ADDENDUM

May 15, 2020

RFB NO. 320012 - ADDENDUM NO. 1

**DANE COUNTY JAIL CONSOLIDATION
COURTHOUSE ELECTRICAL VAULT RELOCATION**

6 3D VIEW
SCALE:

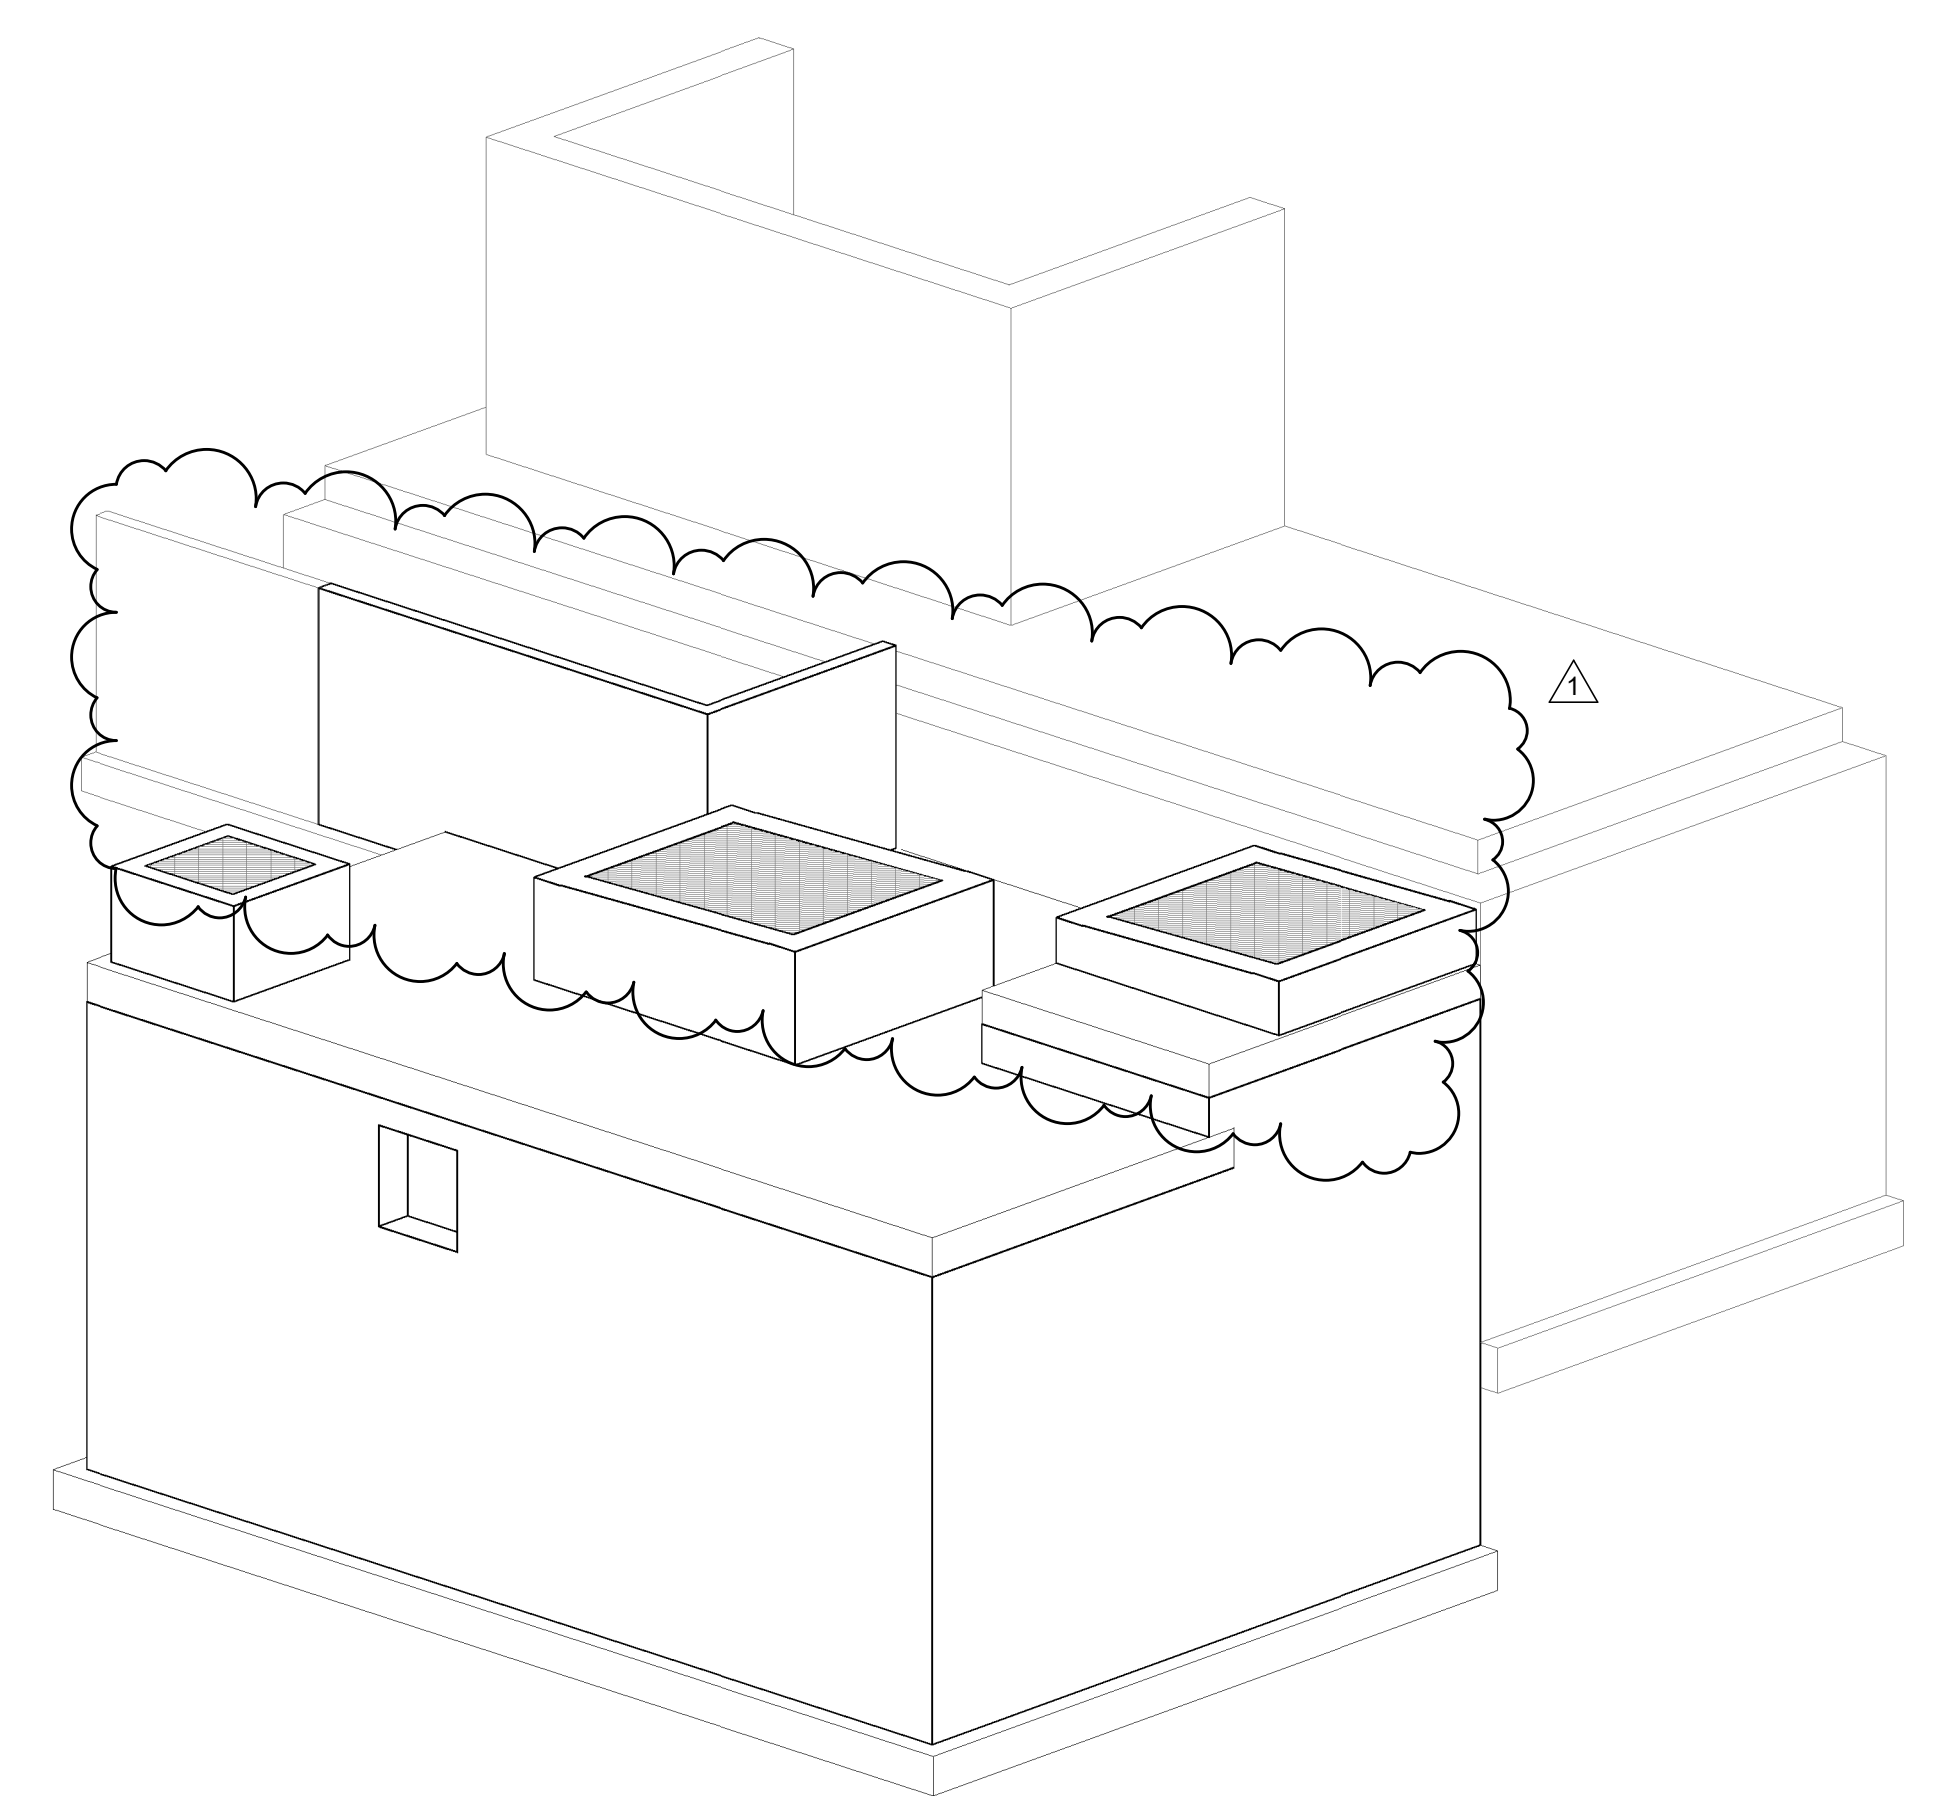
- f. Reference 6/S100 and note the updated 3D diagrammatic sketch.

4 ELECTRICAL VAULT ELEVATION
SCALE: 1/4" = 1'-0"

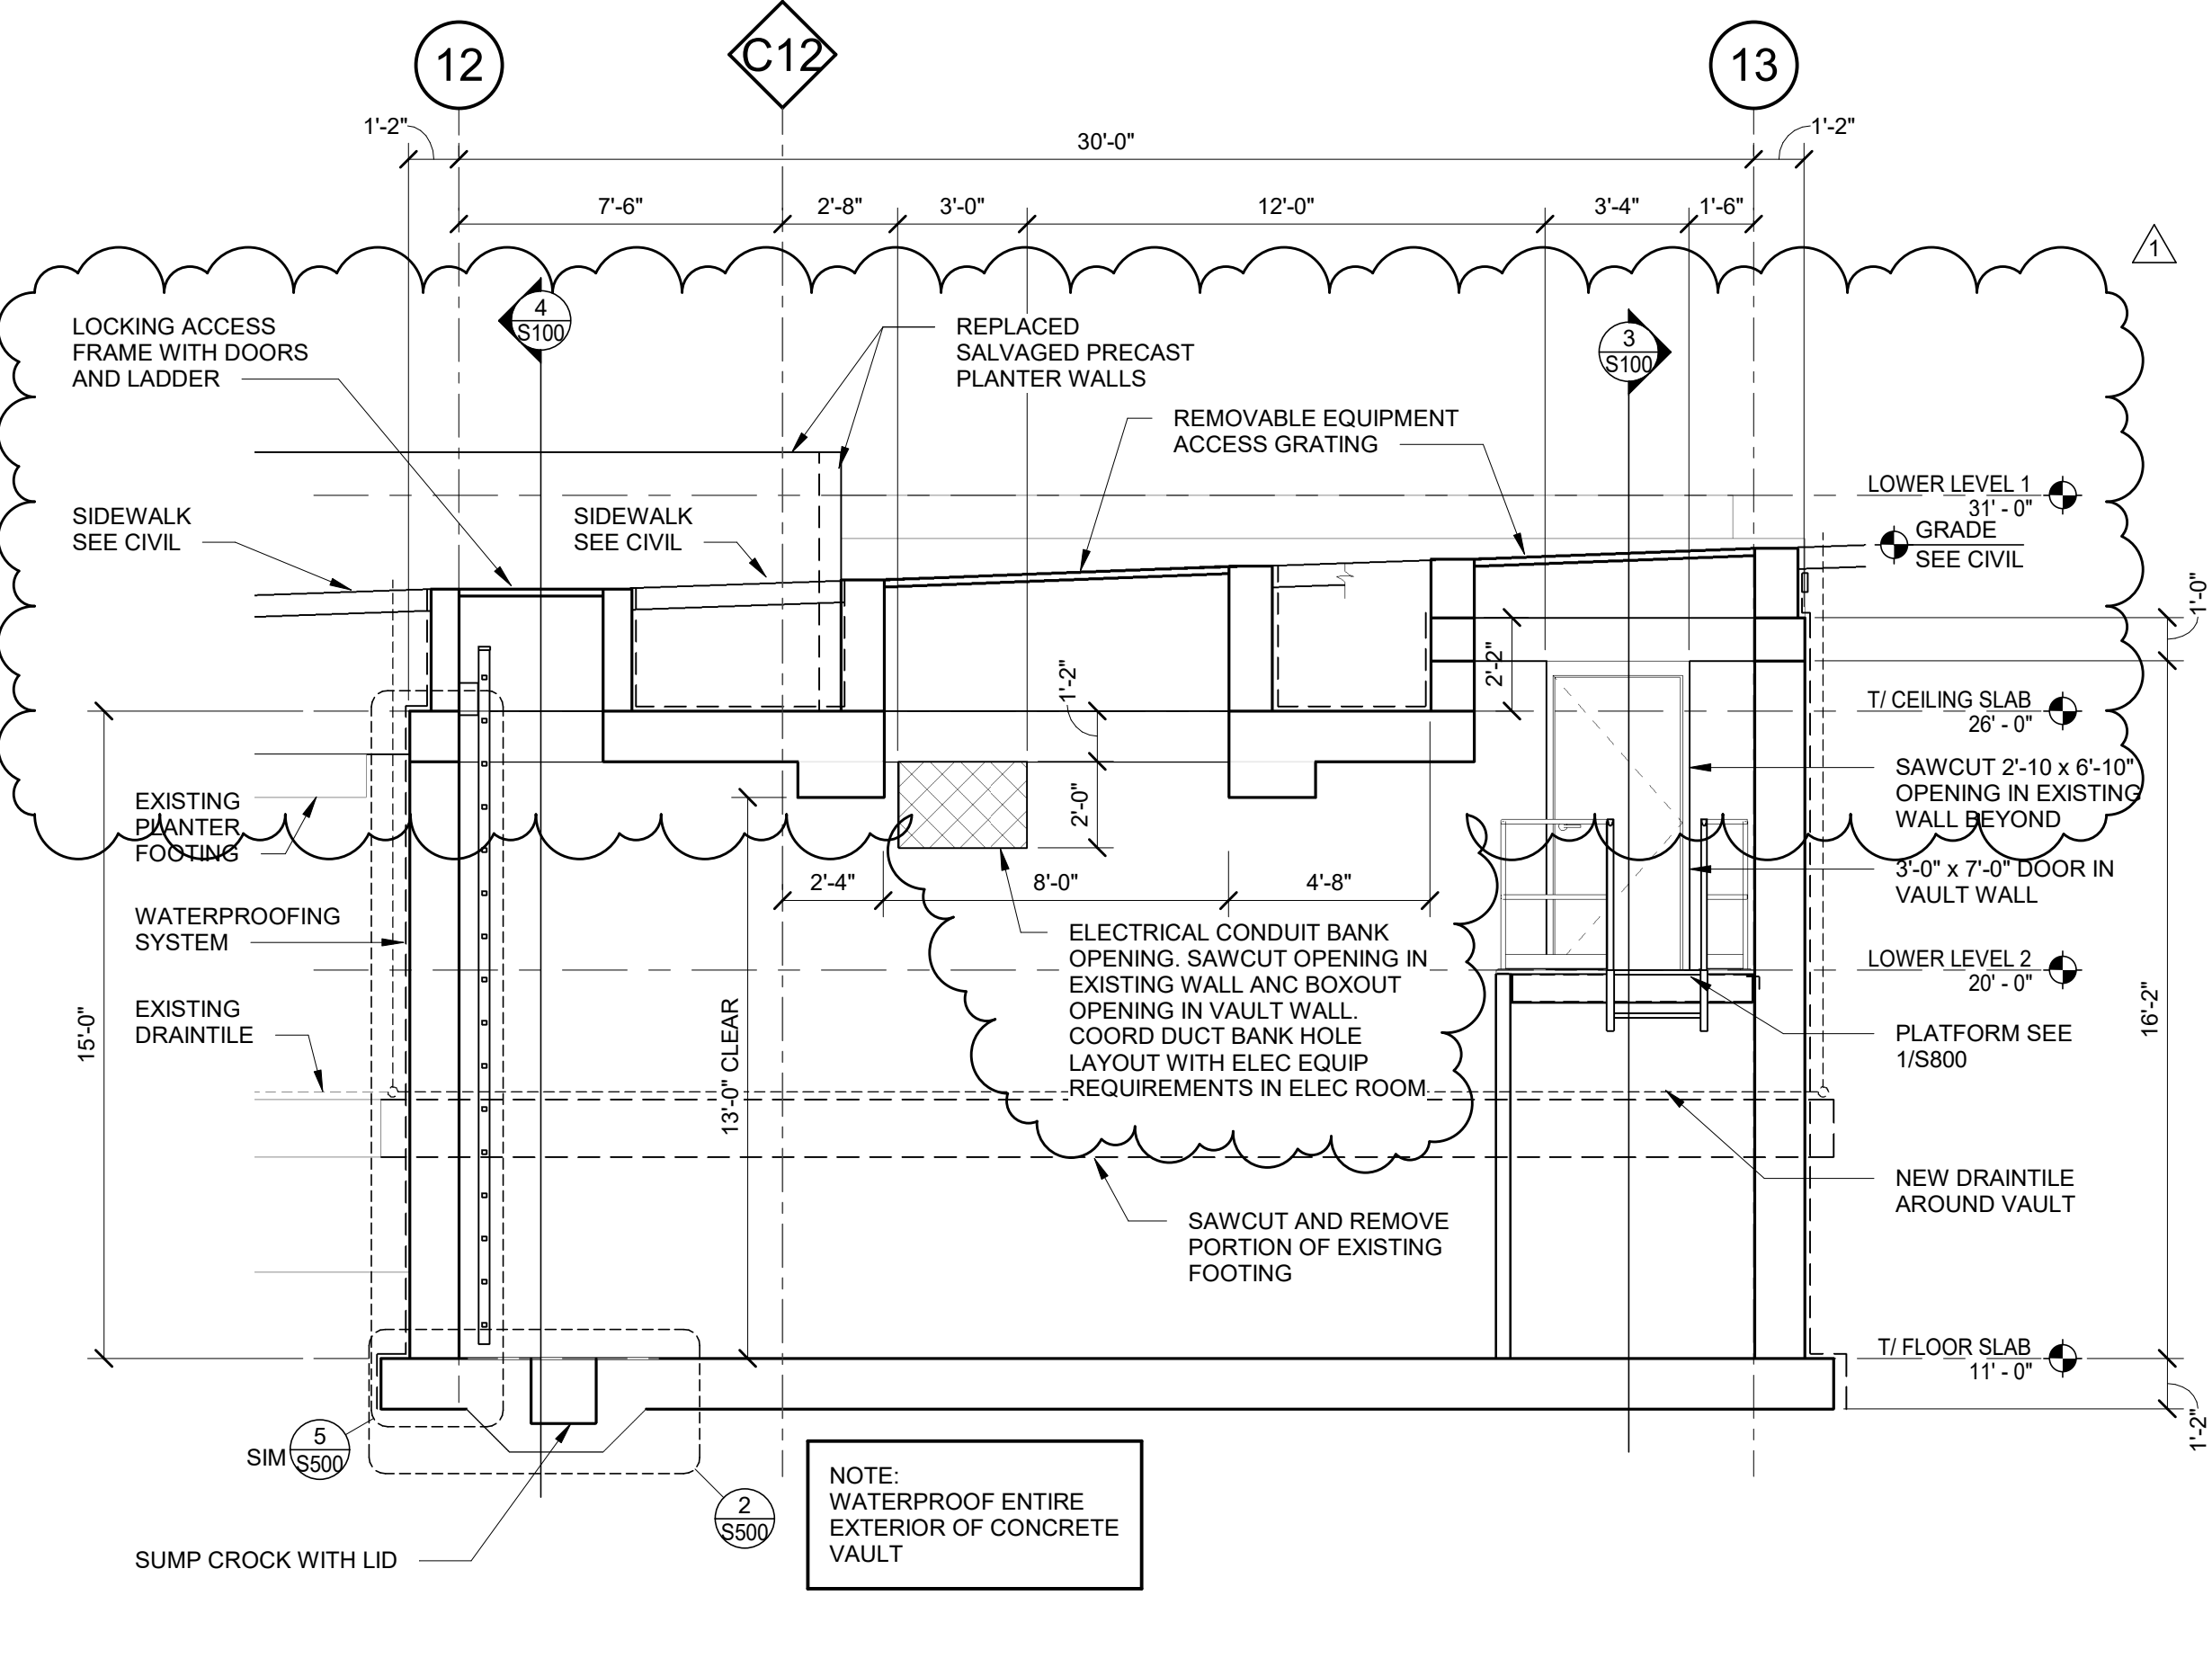
- c. Reference 3/S100 and note the added ventilation port with steel grating, and the dimensional change to the landing platform.
- d. Reference 4/S100 and note the removal of the planter box wall, removal of the ventilation port, and the addition of commentary regarding remediation of the existing foundation wall surface that is becoming exposed to public view.

5 ELECTRICAL VAULT SECTION
SCALE: 1/4" = 1'-0"

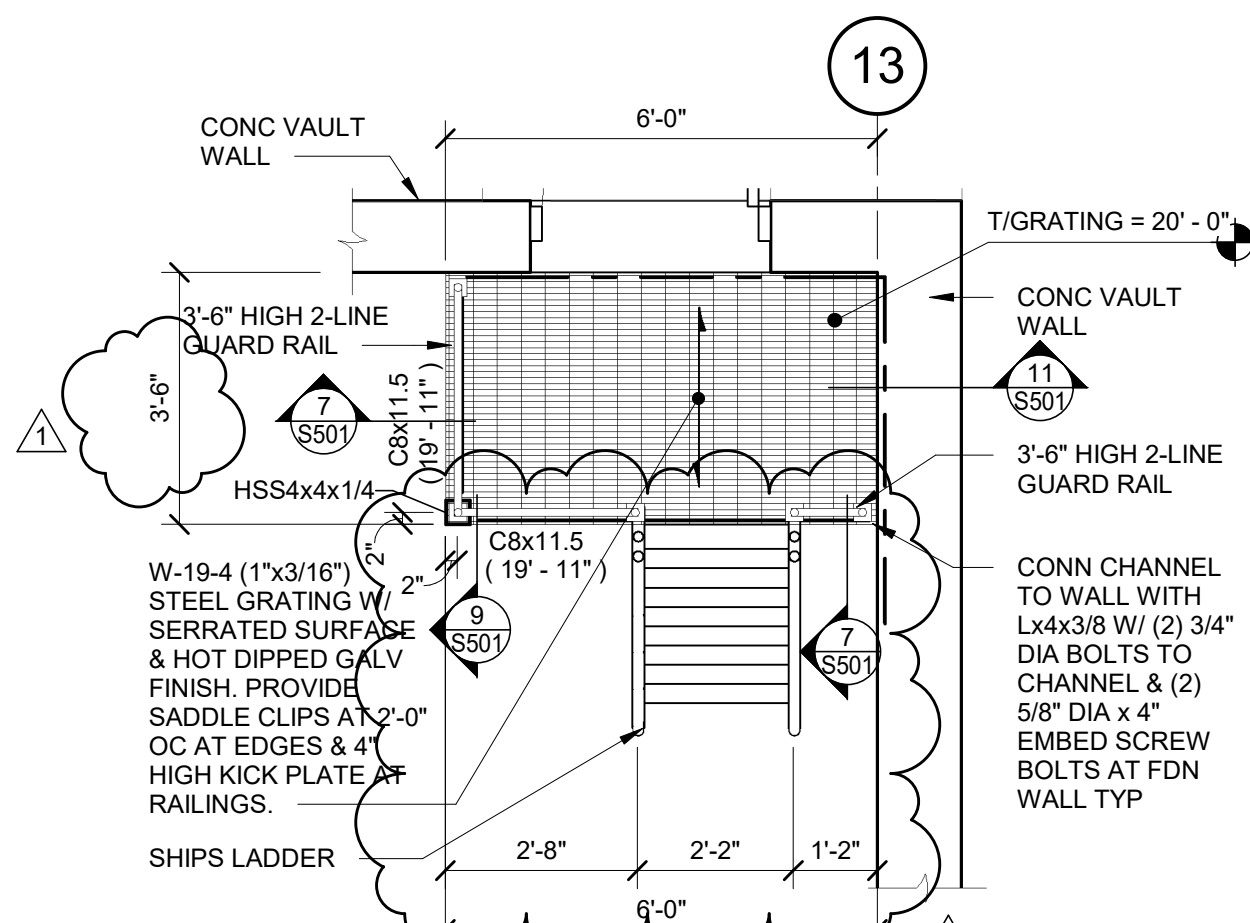
- e. Reference 5/S100 and note the removal and relocation of the planter box walls, revision to the equipment access lid framing for cast concrete to steel grating, the addition of the ventilation port with steel grating above the access platform, and additional commentary regarding the coordination requirements for the concrete encased box conduit.

8 LID SECTION AT BEAM
SCALE: 3/4" = 1'-0"

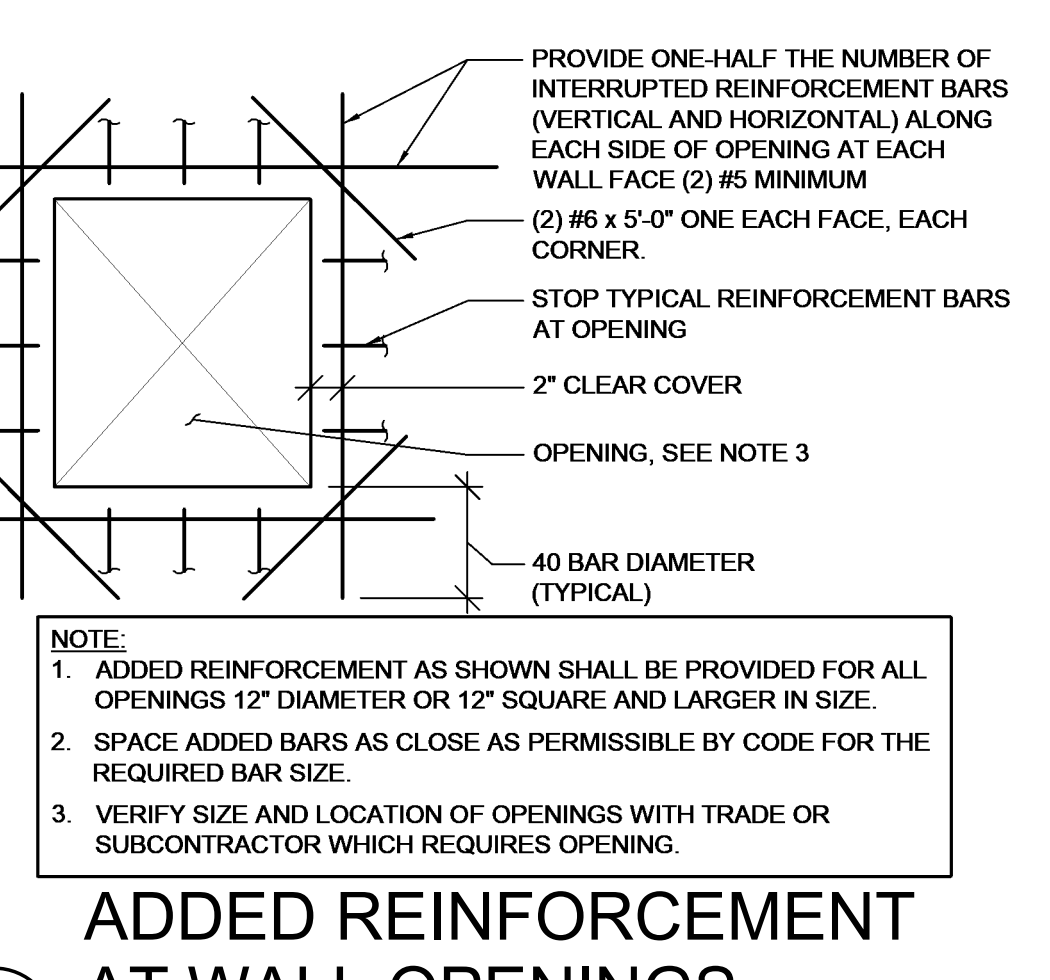
1. Reference 1/S500 and note the dimensional changes.
2. Reference 7/S500 and note the added detail commentary to change from a cast concrete lid to a steel grated lid and the equipment access opening and the vent port.
3. Reference 8/S500 and note the added detail commentary to change from a cast concrete lid to a steel grated lid and the equipment access opening and the vent port.
